GLISAN COMMONS - PHASE II

DESIGN REVIEW 12.05.2013

CARLETON HART
ARCHITECTURE

DESIGN REVIEW SUMMARY

1. MATERIALS

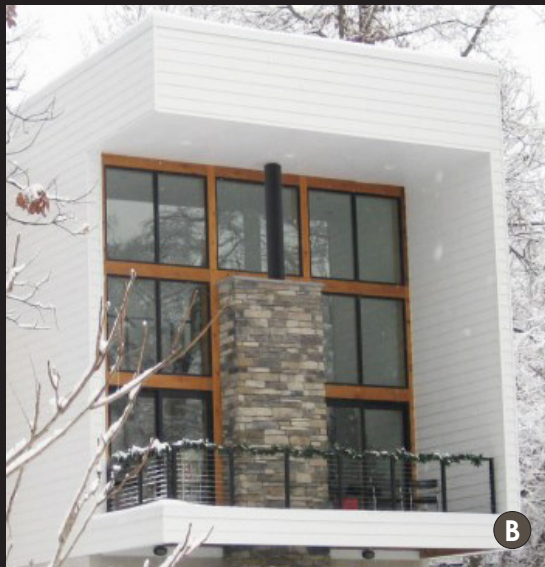
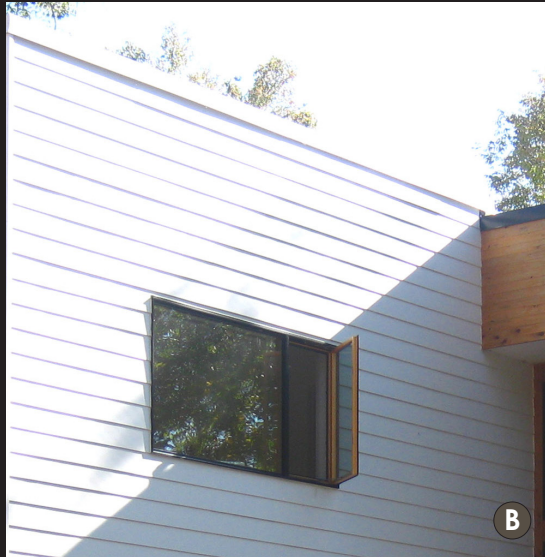
- EXECUTE MATERIALS TO MASSING CONCEPT WITH MORE RIGOR
- SIMPLIFY MATERIALS PALETTE

- LIMIT USE OF PANEL TO RECESSED LOCATIONS
- OMIT PANEL CLAD COLUMNS
- REVISE GROUND FLOOR METAL PANEL SIDING

ENLARGED PLANTER BUFFER

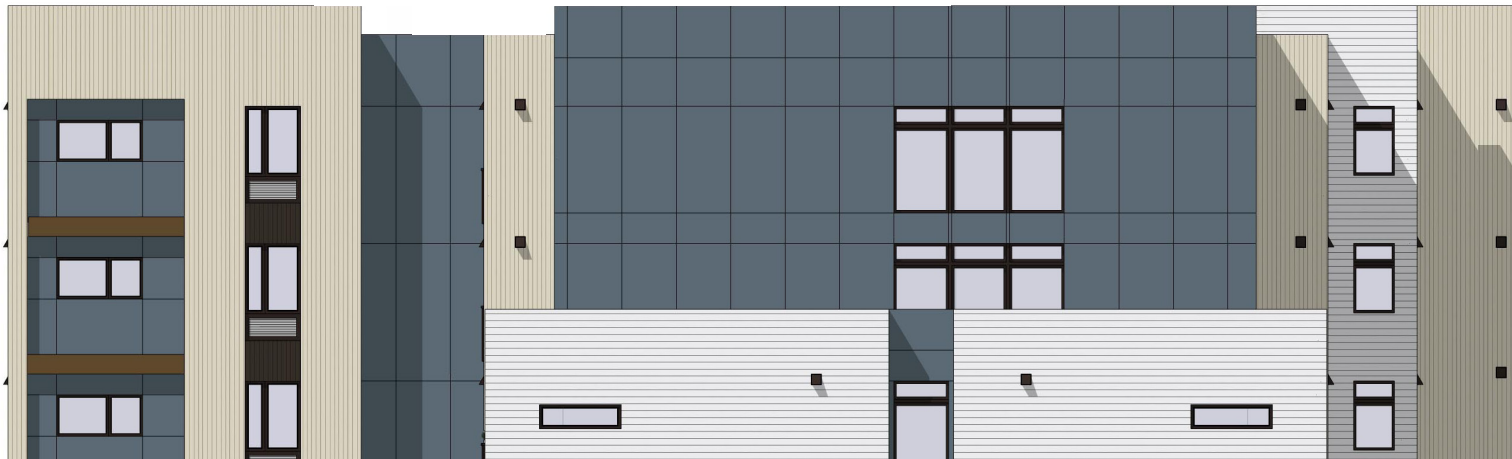
- SIMPLIFY RECESSED FORMS & MATERIALS
- RELATE MAIN ENTRY TO MASSING ABOVE
- OMIT CENTER COMMON BALCONIES
- HEIGHTEN PEDESTRIAN EXPERIENCE WITH RAISED PLANTER & SEATING

STAIR TOWER MASSING

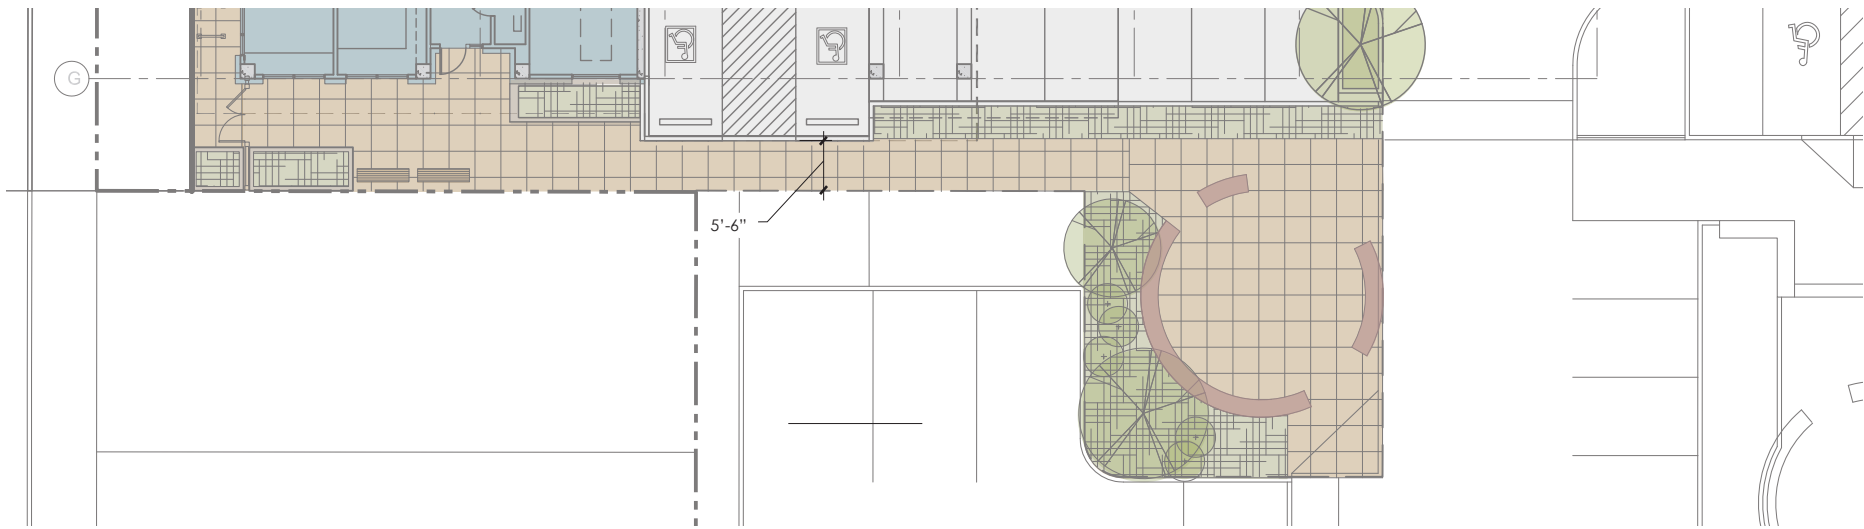
- SIMPLIFY MASSING AT EAST STAIR TOWER / LOWER ROOF
- RELATE WEST GARAGE WALL TO NORTH WALL, PROVIDE INTEREST

PEDESTRIAN PATH

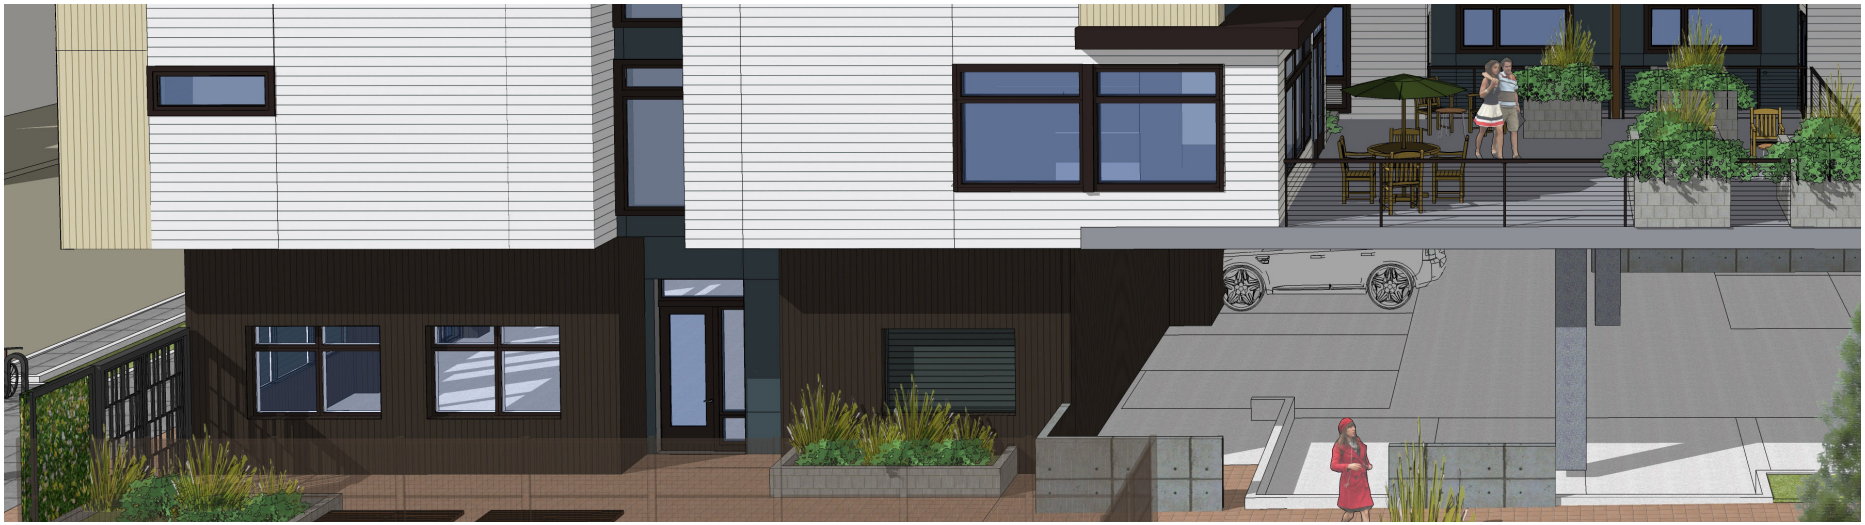
- INCREASE WALKWAY WIDTH ADJACENT TO ACCESS. PARKING SPACES
- ENHANCE LANDSCAPE SCREENING BETWEEN GARAGE & PATHWAY
- PROVIDE A COVERED CONNECTION FROM PARKING TO LOBBY

MODIFICATIONS

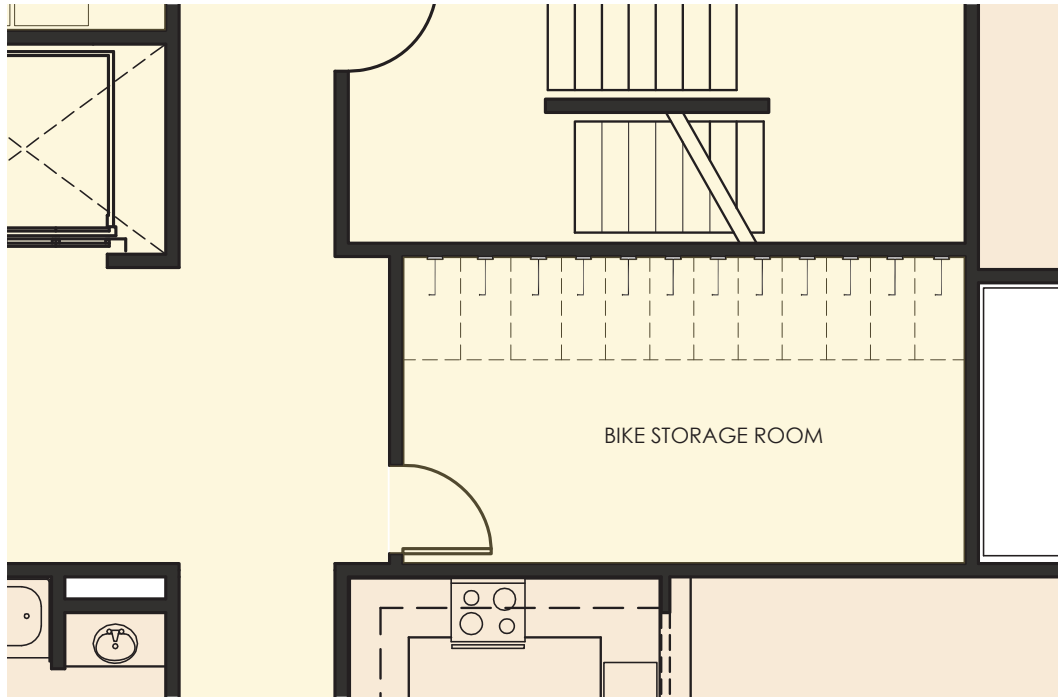
- FRONTAGE REQUIRED TO MEET 'GROUND FLOOR WINDOW' STANDARD OF CX ZONE
- LOBBY/OFFICE MEETS WINDOW AREA REQUIREMENT (50%) AND PARKING GARAGE WALL IS SET BACK THE MIN. 5' WITH LANDSCAPE BUFFER (50%) TO MEET STANDARD
- PEDESTRIAN STANDARDS REQUIRE 75% OF FACADE TO BE AT LOT LINE OR WITHIN 12' & DESIGNED AS A SIDEWALK EXTENSION
- BUILDING DOES NOT MEET BOTH REQUIREMENTS SIMULTANEOUSLY, REQUEST A MODIFICATION TO 'BUILDING LINES' STANDARD

1. PROVIDE LANDSCAPING IN LIEU OF PAVING TO BUFFER GARAGE, NOT INCLUDING TREES PER L2 STANDARD.
2. PROVIDE STAGGERED WALL MOUNT BIKE RACKS AT 1'-6" SPACING INSTEAD OF 2'-0"
3. PROVIDE ALTERNATE LANDSCAPING WIDTHS AND MATERIALS ALONG SOUTH PARKING STALLS IN PLACE OF 5'-0" BUFFER

MODIFICATIONS - BICYCLE STORAGE

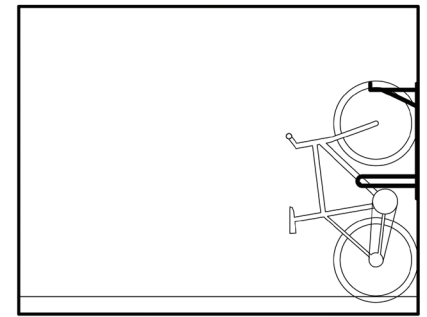
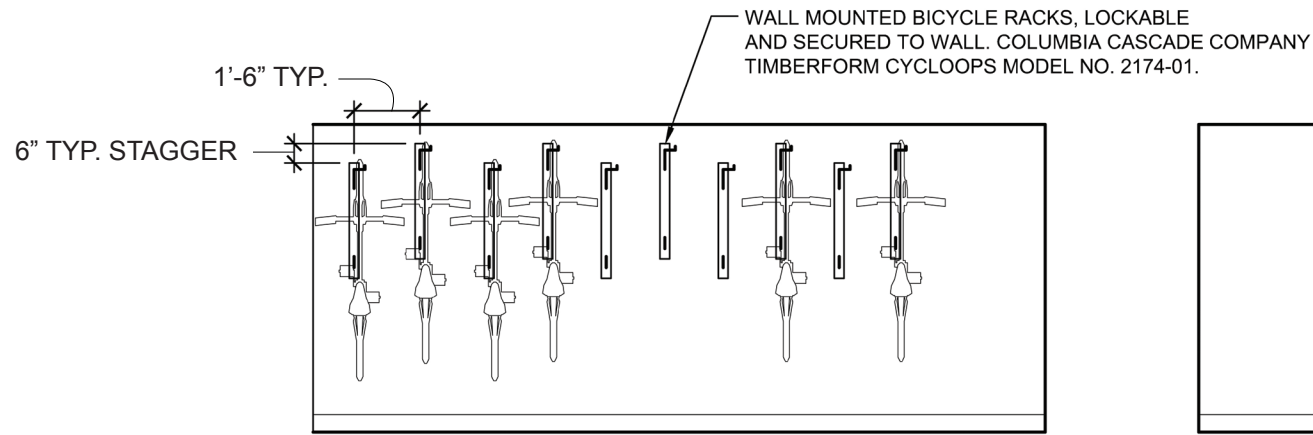
- BICYCLE STORAGE ROOM ON ALL 5 RESIDENTIAL FLOORS
- ADJACENT TO ELEVATOR
- TOTAL OF 70 SPACES
- 66 (1.1 PER UNIT) LONG TERM REQUIRED PER ZONING
- REQUEST A MODIFICATION TO REQUIRED SPACING TO PROVIDE THE REQUIRED NUMBER OF BIKE SPACES IN WALL RACKS
